TMC SPECIFICATION

NO. S 1156

SPECIFICATIONS

KIT-273

FIG. 1
LEFT REAR VIEW
OF MAIN FRAME

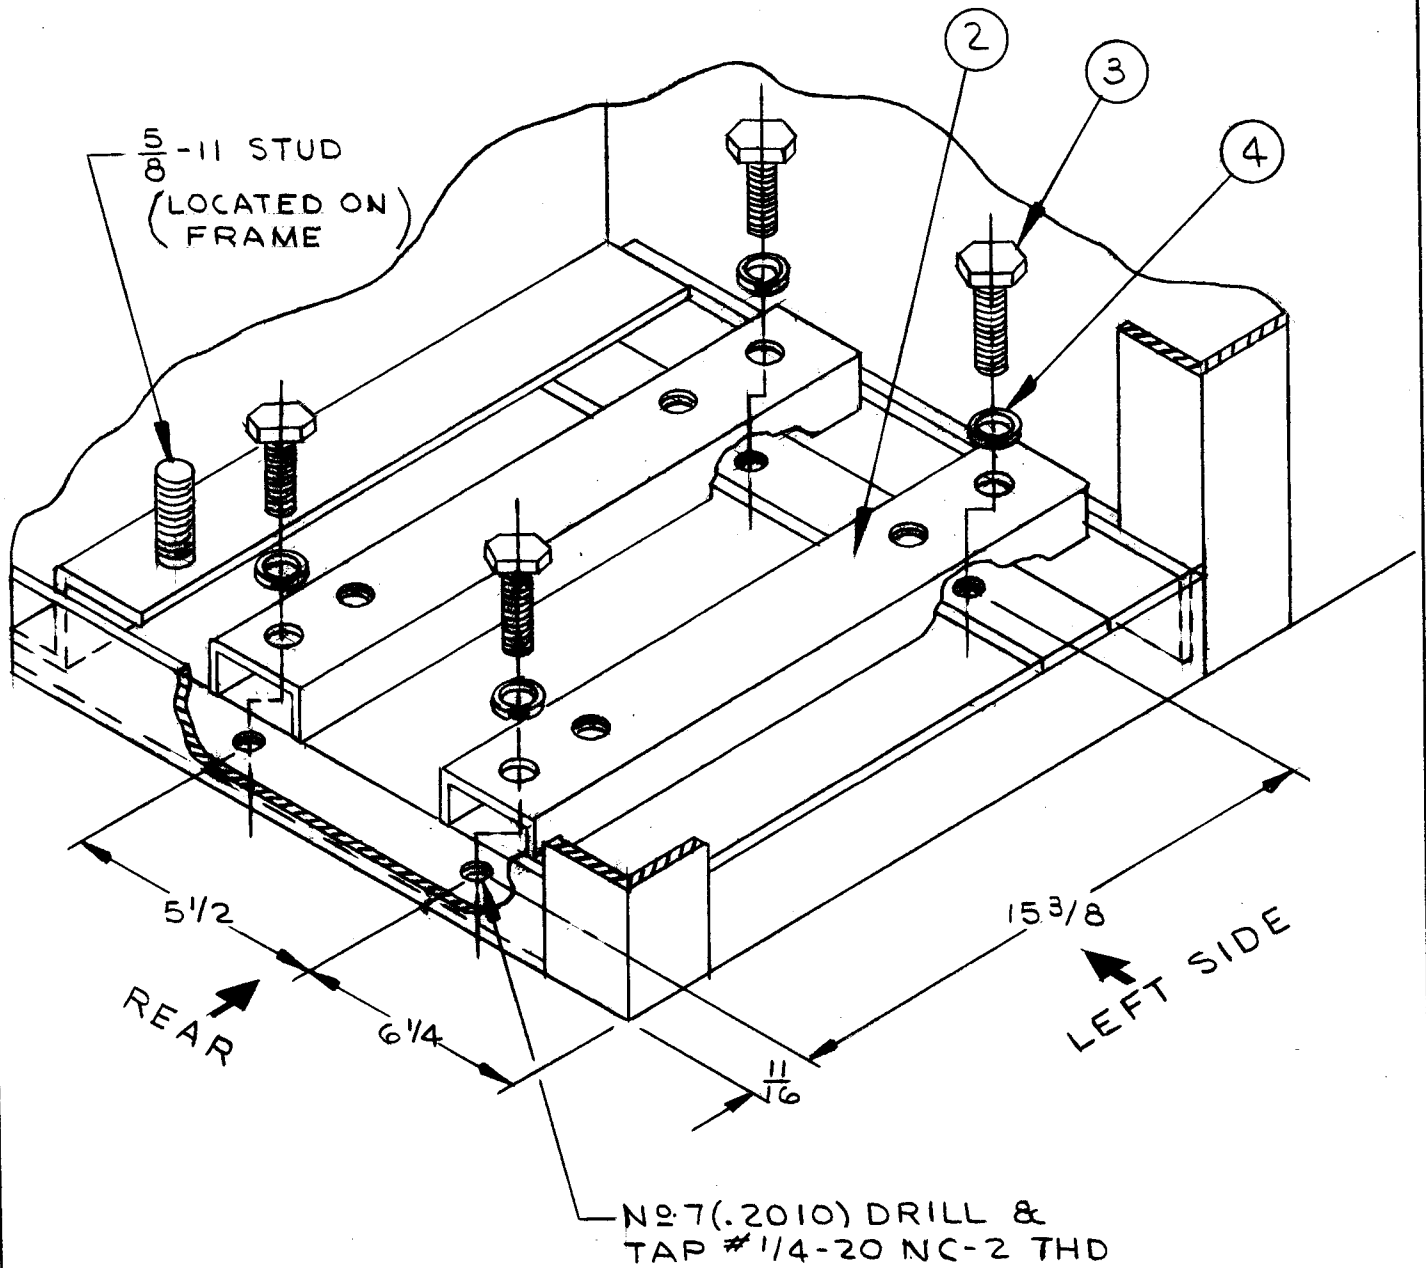
3. Refer to Figure 1. Using qty 1 Item 13 (DRILL,1/8), drill pilot holes. Drill pilot holes to required diameter using qty 1 Item 14 (DRILL,#7(.2010) and tap with qty 1 Item 15 (TAP,#1/4-20 NC-2 THD). Place Item 2 (MS6038) as shown.

4. Using qty 4 Item 3 (SCHH2520BN28) and qty 4 Item 4 (LWS25MRN), secure qty 2 Item 2 (MS6038) in place as shown in Figure 1.

FIGURE III.
ADDENDUM TO MAIN PWR
CIRCUIT GPT-10K SCHEM

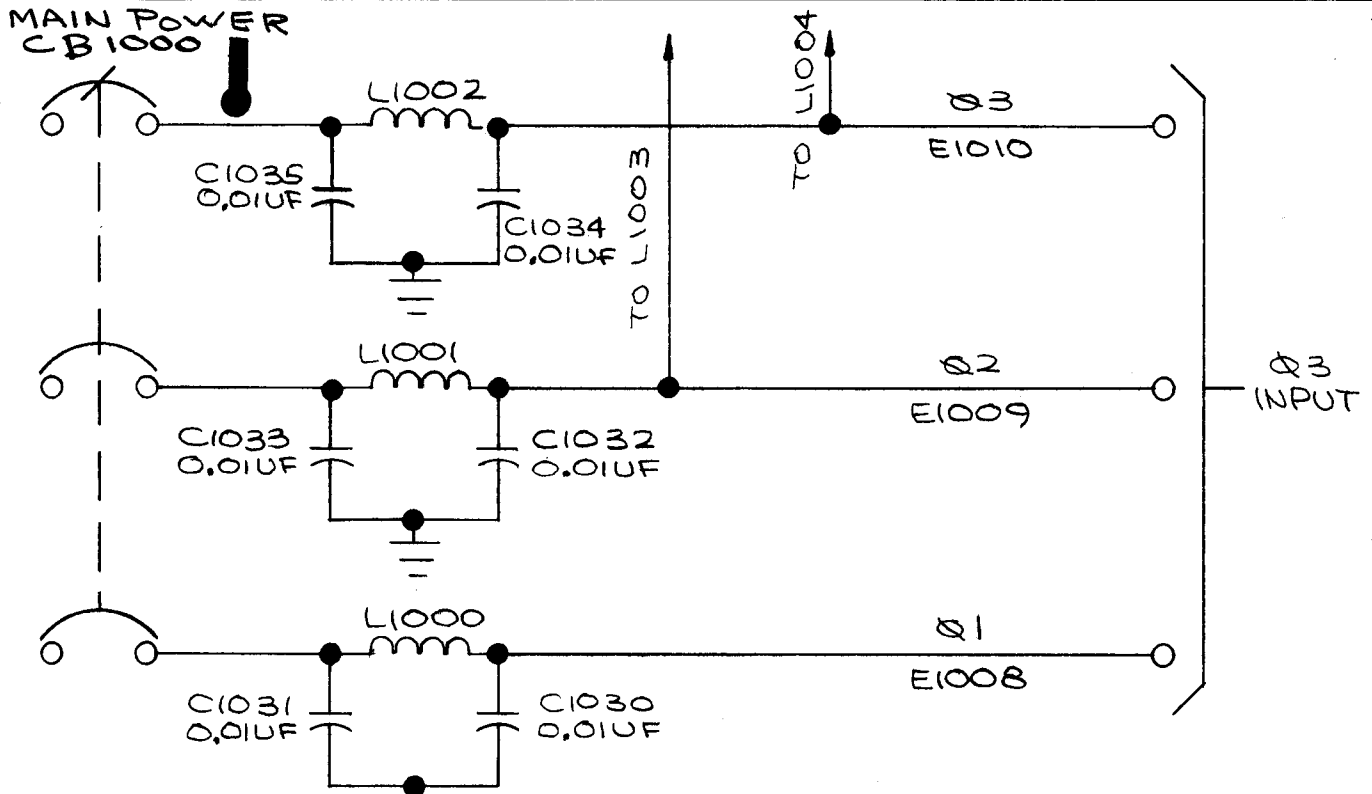
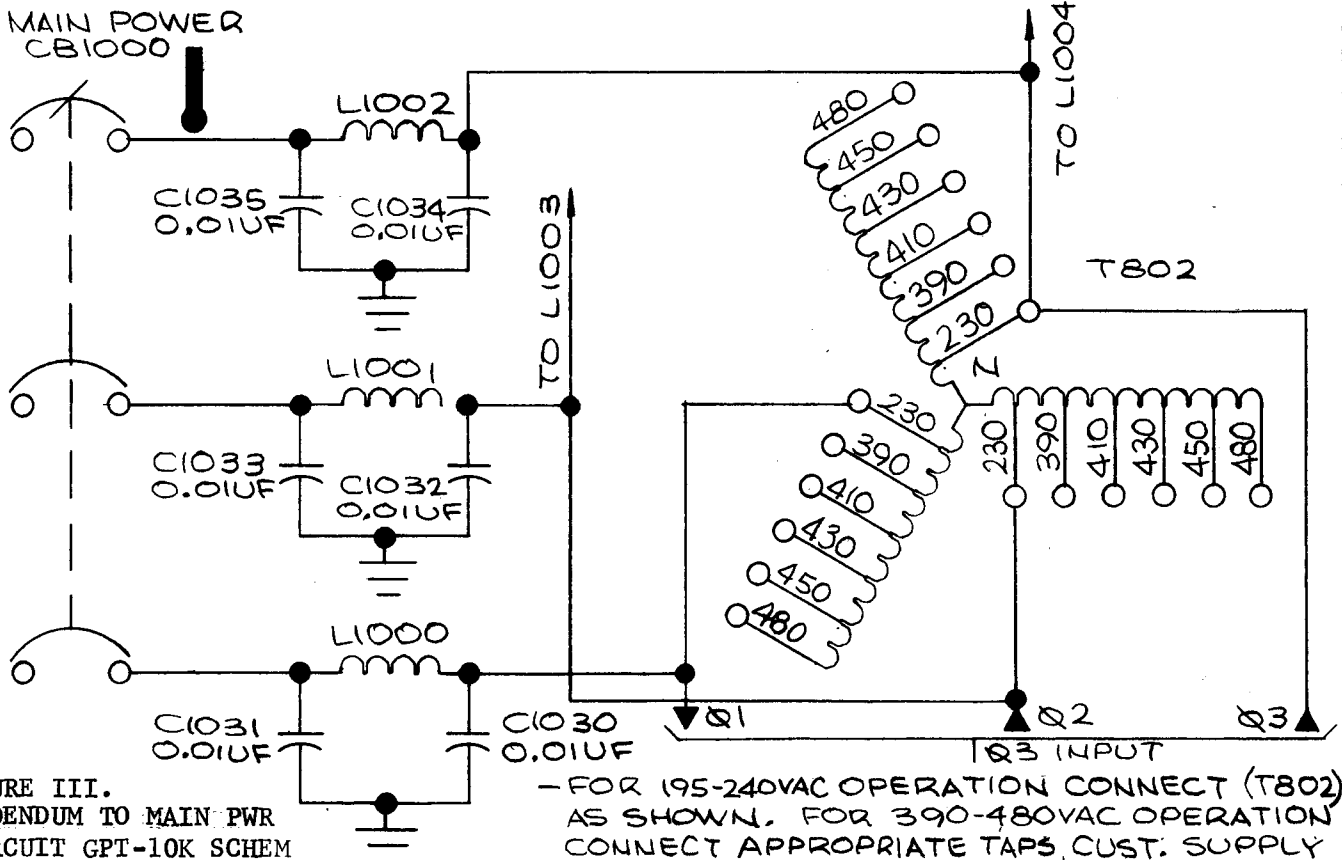
4. Refer to Figure II main power circuit and on your schematic revise as to comply with Figure III.

- FOR 195-240VAC OPERATION CONNECT (T802) AS SHOWN. FOR 390-480VAC OPERATION CONNECT APPROPRIATE TAPS. CUST. SUPPLY 50 OR 60cps UNGROUNDED. PHASE SEQ Q1, Q2, Q3

FIGURE IV

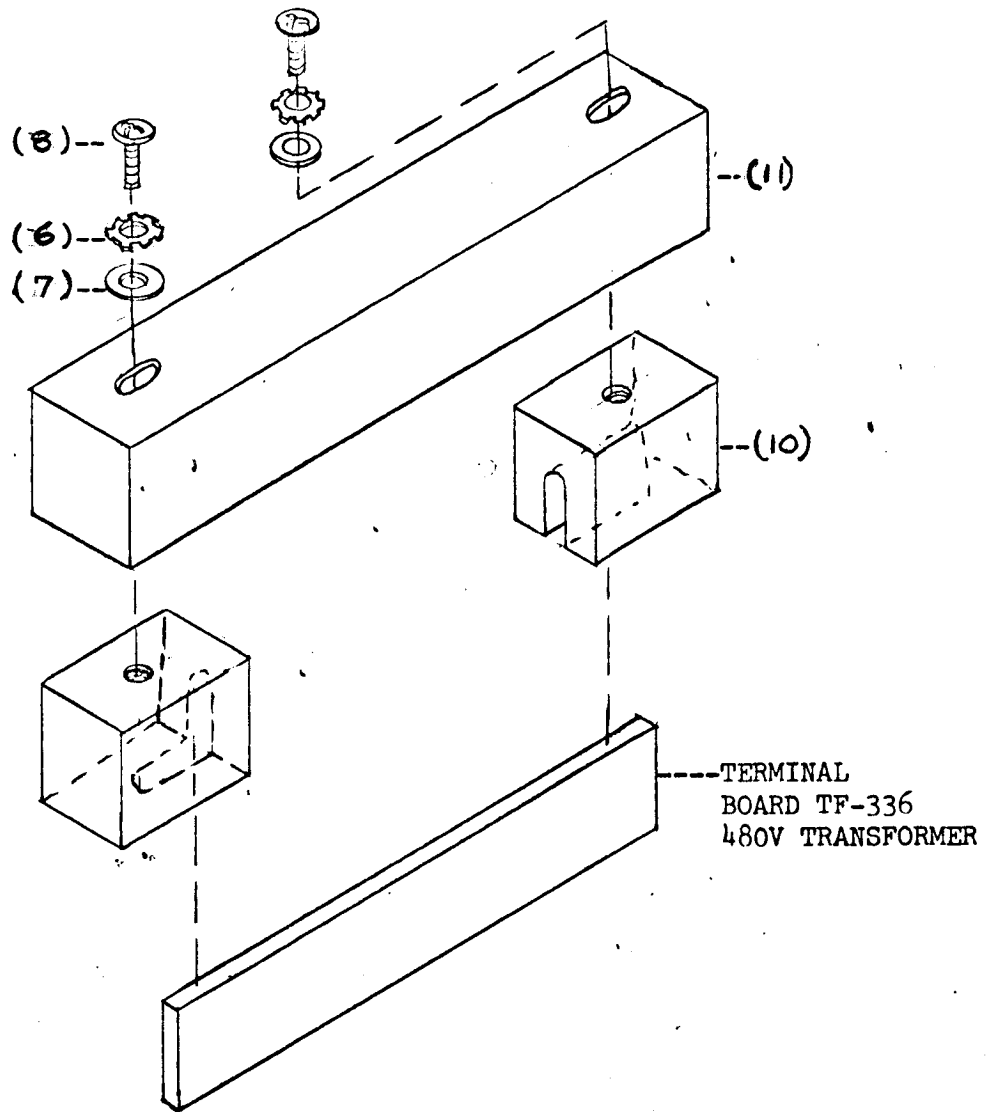
1. Mount qty 2 Item 10 (PX1002) straddling the 3/8 inch thick terminal board of xfmr as indicated in Figure IV.

2. Position qty 1 Item 11 (LD2181/PX973-1) on Item 10 (PX1002) and mount with qty 2 Item 7 (FW10HBN), qty 2 Item 6 (LWE10MRN) and qty 2 Item 8 (SCBP1032BN8).

3. Tighten the blocks inward so as to remove slack and sandwich xfmr terminal board into slots of Item 7 (LD2181/PX973-1).
